## SAFETY EVALUATION

### FACILITY OPERATING LICENSE NO. DPR-43

#### KEWAUNEE POWER STATION

#### DOCKET NOS. 50-305 AND 72-64

**Figure 1**  
**NAC Secure Lift System**  
**and Stack-Up Configuration**

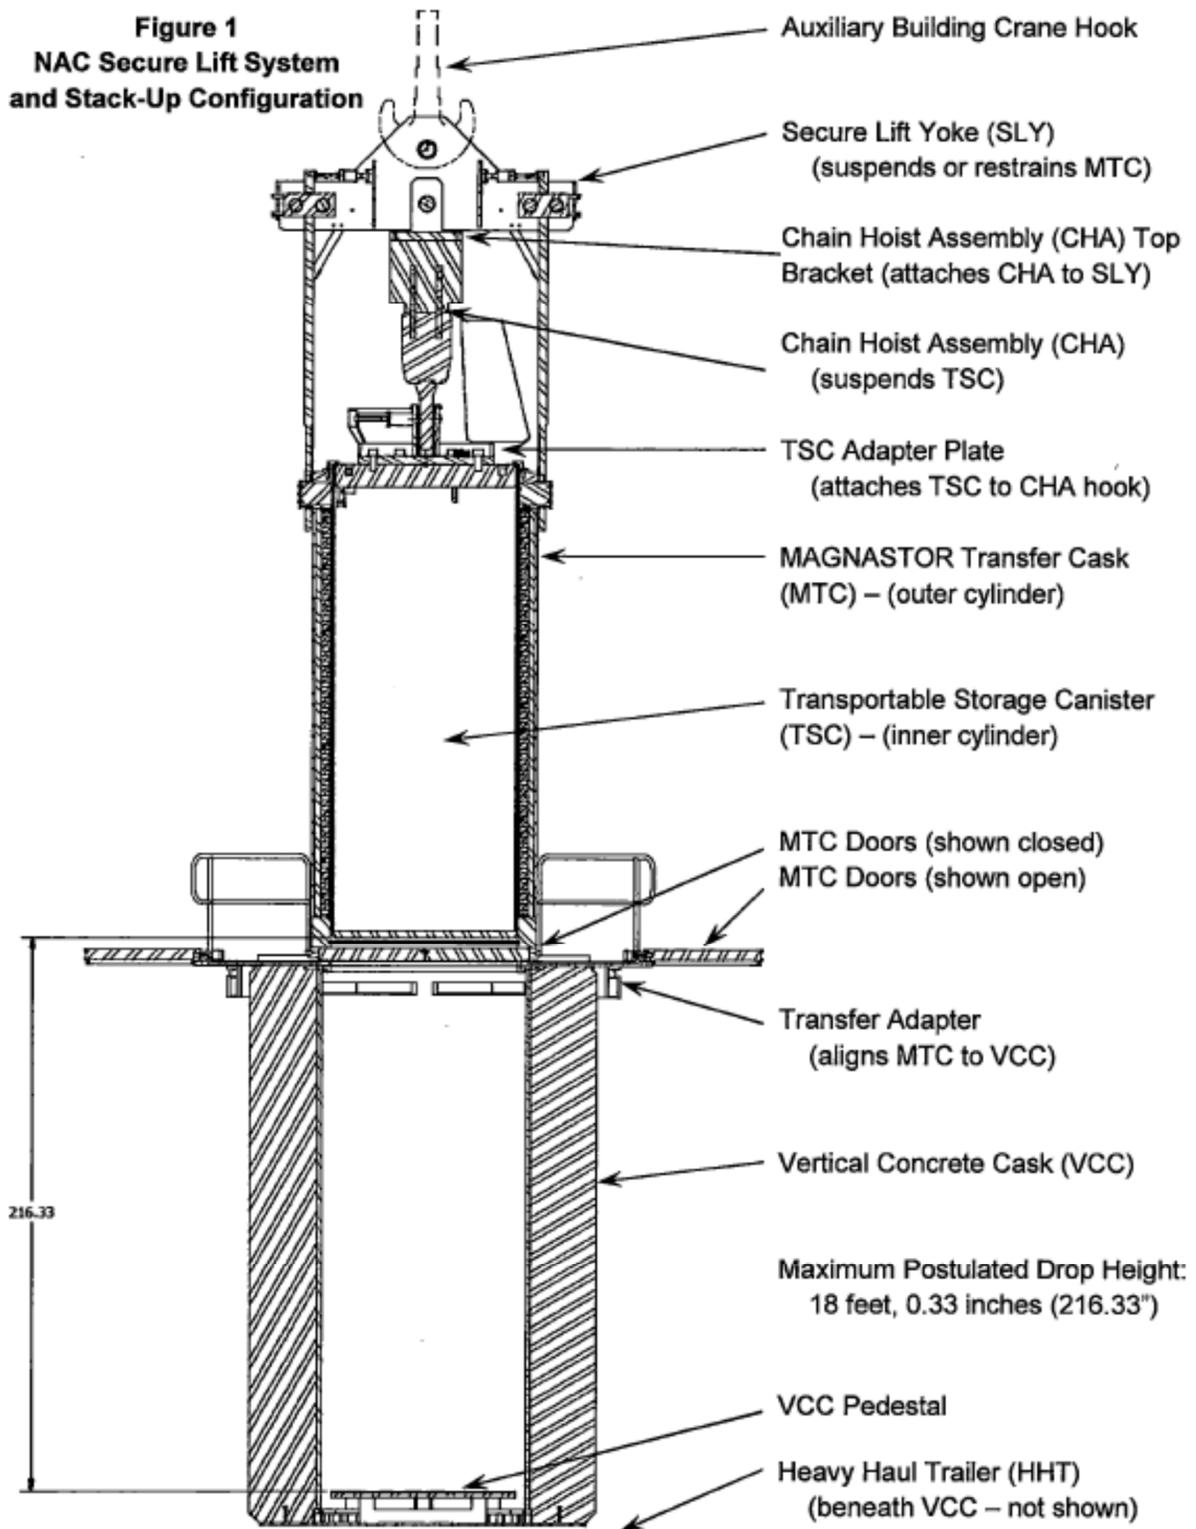
The cask loading operations use the NAC secure lift system for certain load movements within the auxiliary building. The secure lift system consists of two parts, the secure lift yoke and the air-driven chain hoist assembly. The secure lift yoke connects the AB crane hook to the MAGNASTOR transfer cask (MTC) and is used to move the MTC from the cask decontamination area to position the MTC in the stack-up configuration above the VCC in the truck bay. The chain hoist assembly is connected to the center of the secure lift yoke immediately below its connection to the AB crane hook. The chain hoist assembly is connected to the TSC by the TSC adapter plate. The chain hoist assembly is used to lift the TSC off the MTC doors so they can be opened and to lower the TSC from the MTC onto the VCC pedestal.

The secure lift yoke is designed to be consistent with the guidance of Section 5.1.6 of NUREG-0612. The secure lift yoke connects to the licensed MTC, and the MTC supports the sealed TSC with its load of spent fuel during the movement from the cask decontamination area to the stack-up configuration above the VCC.

Once in the stack up configuration, the chain hoist assembly is connected to the TSC and the chain hoist assembly is used to lift the TSC off the MTC doors. The chain hoist assembly is not consistent with guidelines of Section 5.1.6 of NUREG-0612 as a single-failure-proof hoisting device. Consequently, a failure of the hoist is considered a credible accident condition. To ensure an acceptable level of defense-in-depth consistent with NUREG-0612 guidelines, the licensee chose to evaluate the consequences of a postulated drop of the loaded TSC from the highest lift height while attached to the chain hoist assembly to the VCC pedestal.
